Site Instruction

SI 24

PROJECT : Hampton Manor
PROJECT No : 1136.13
DATE : August 14, 2018

Title: Removal of Insulation behind Precast

section detail @ roof/precast panel
SCALE - 1/8" = 1'-0"

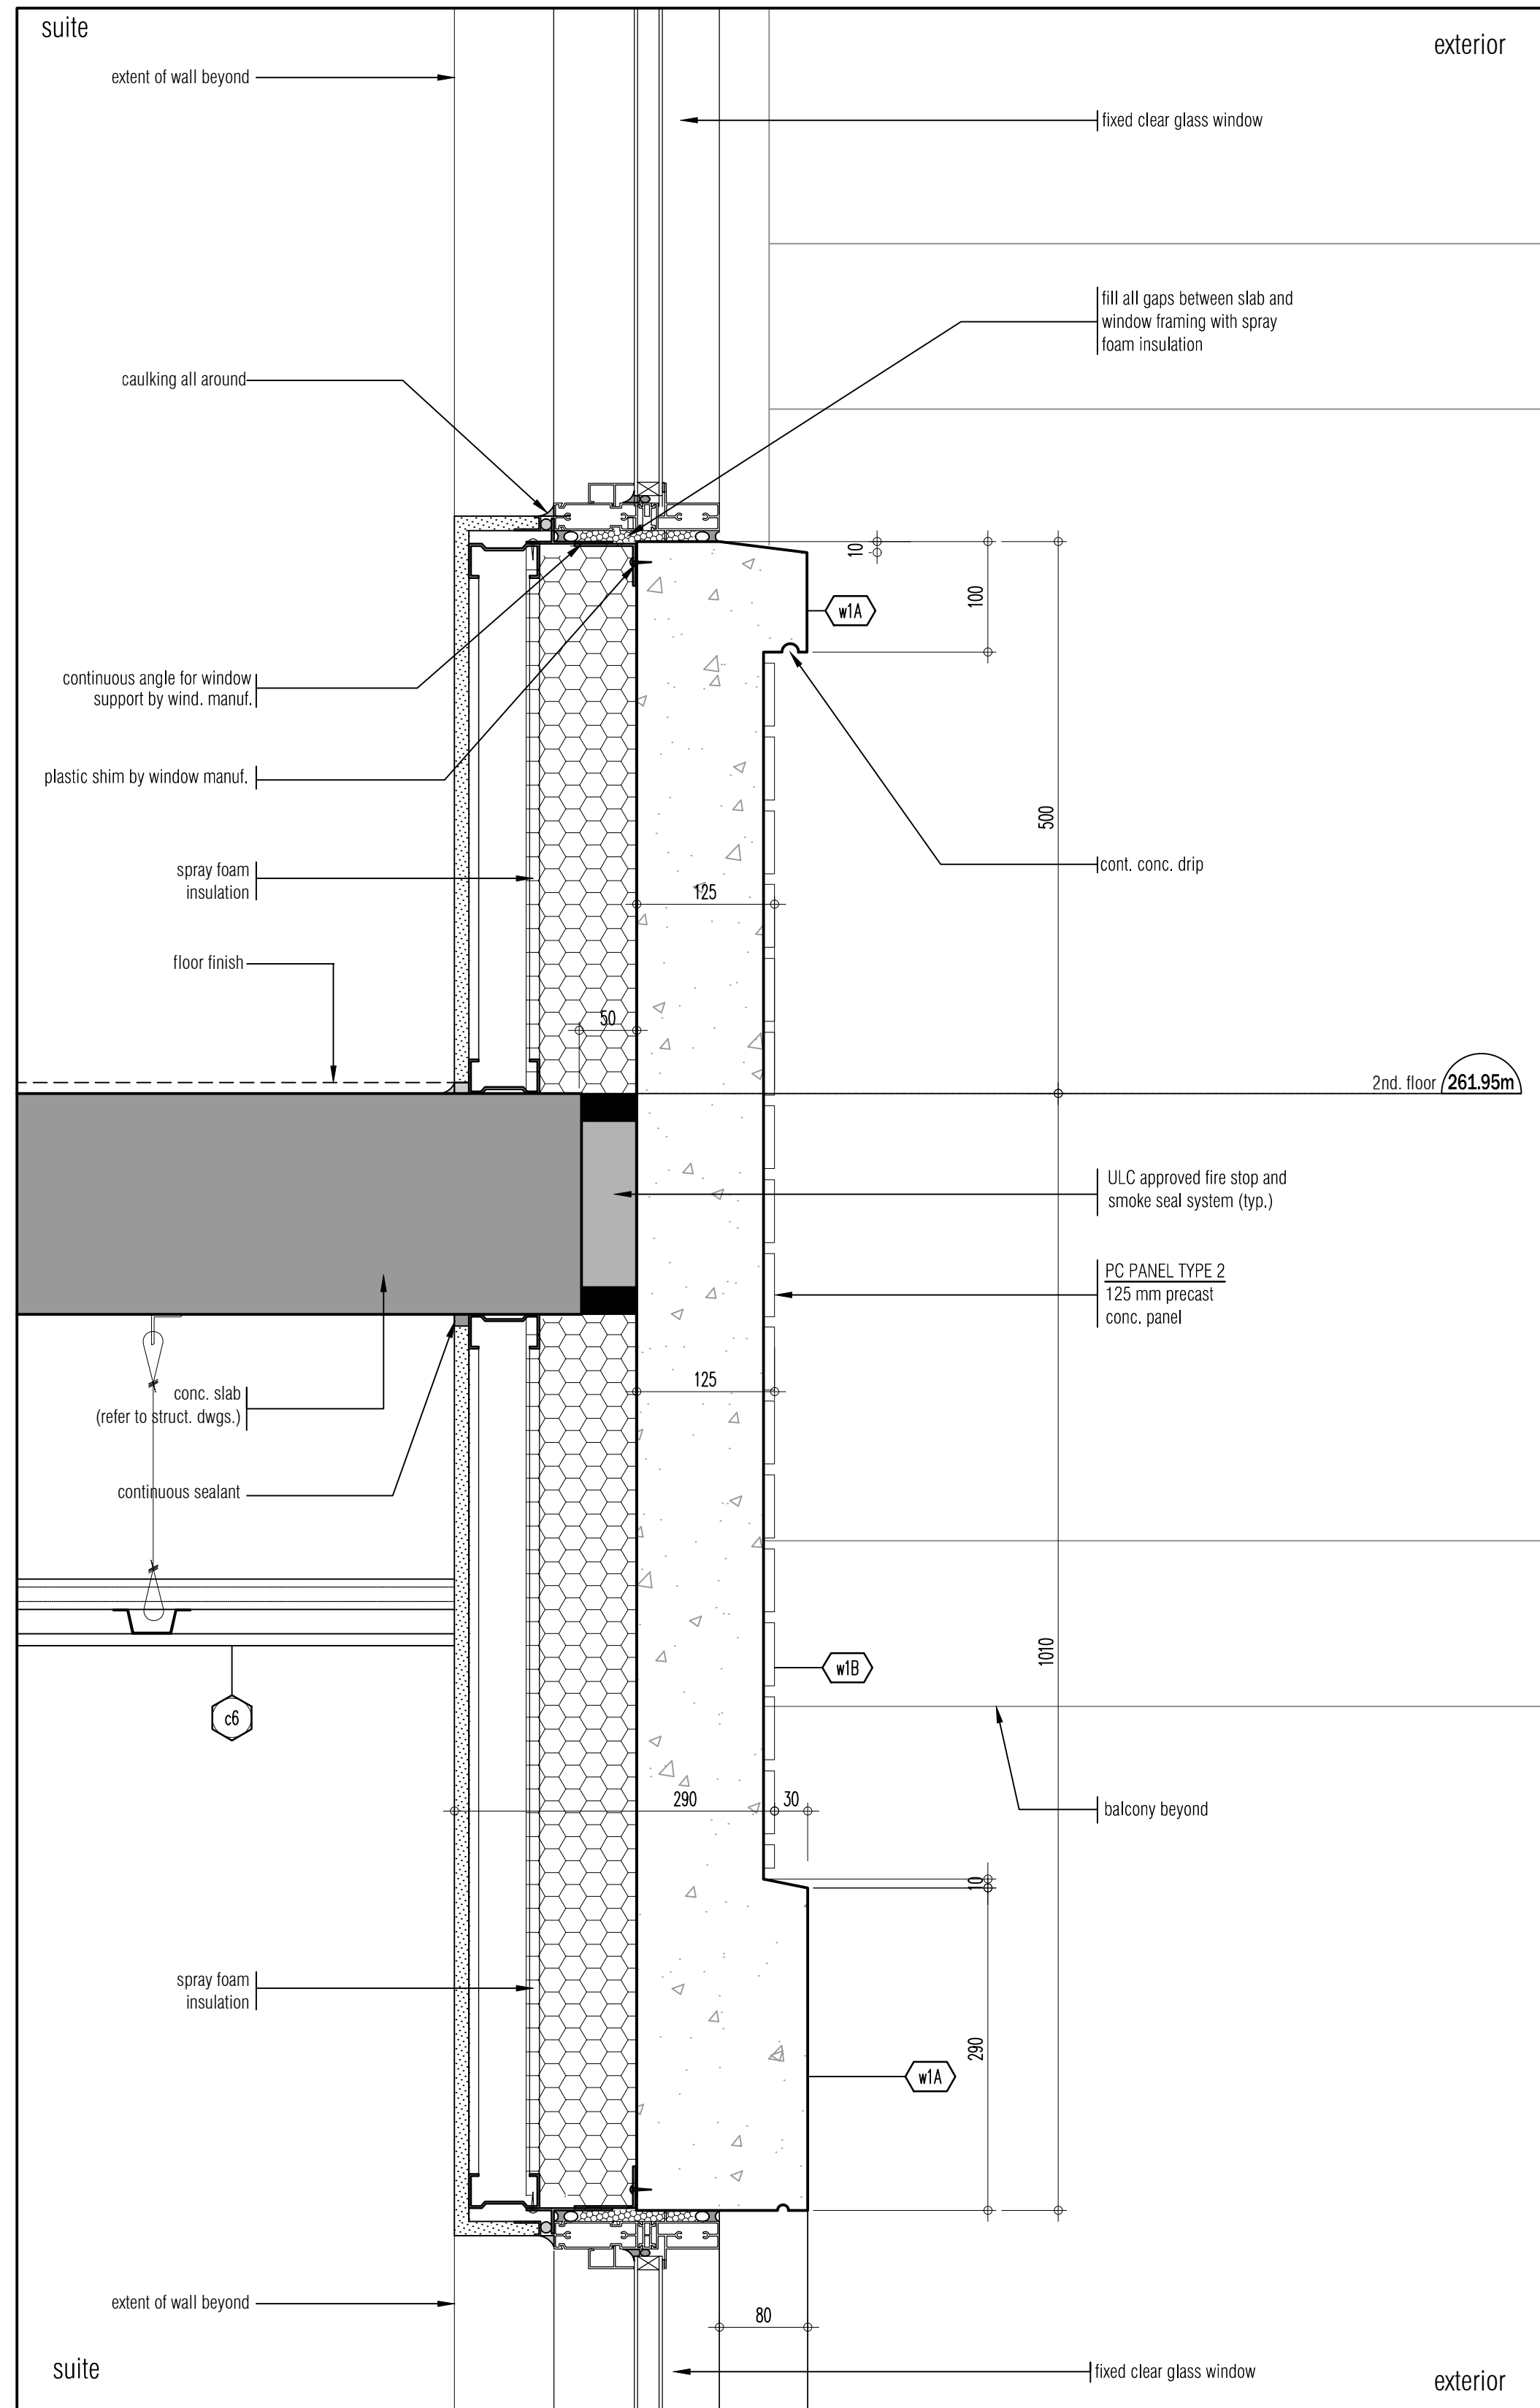
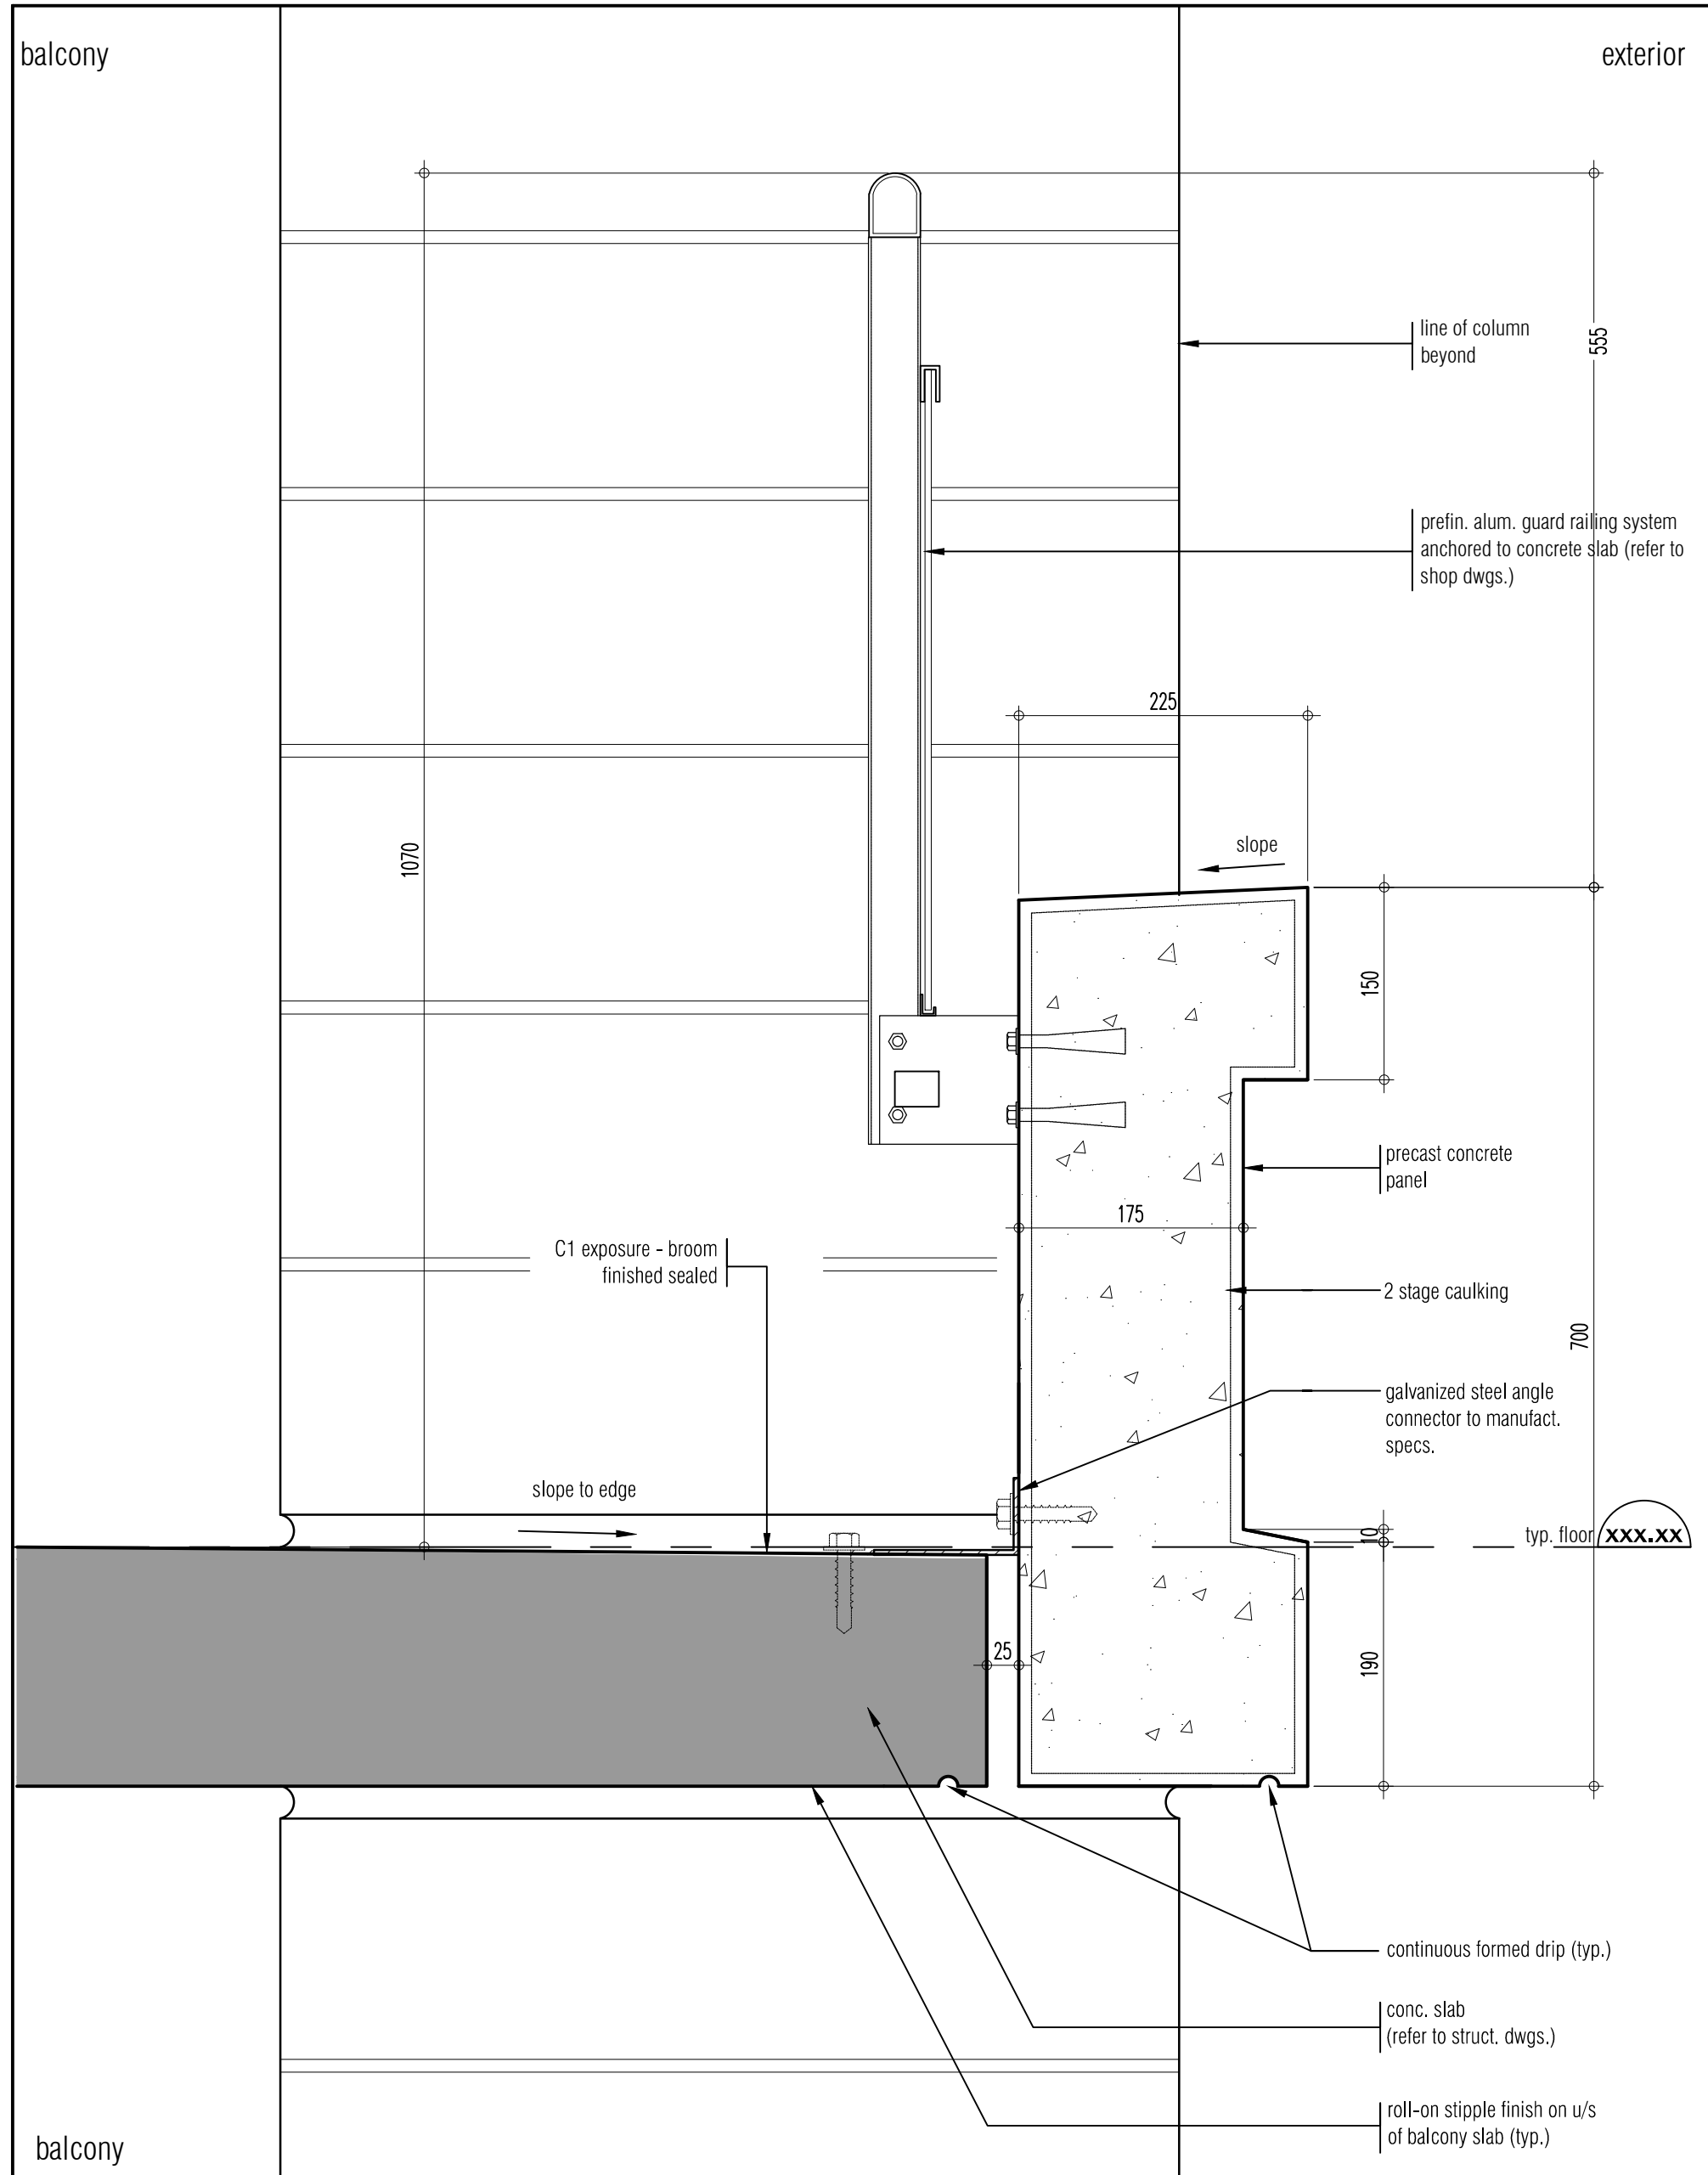
- Removal of insulation behind precast at terraces and roof.
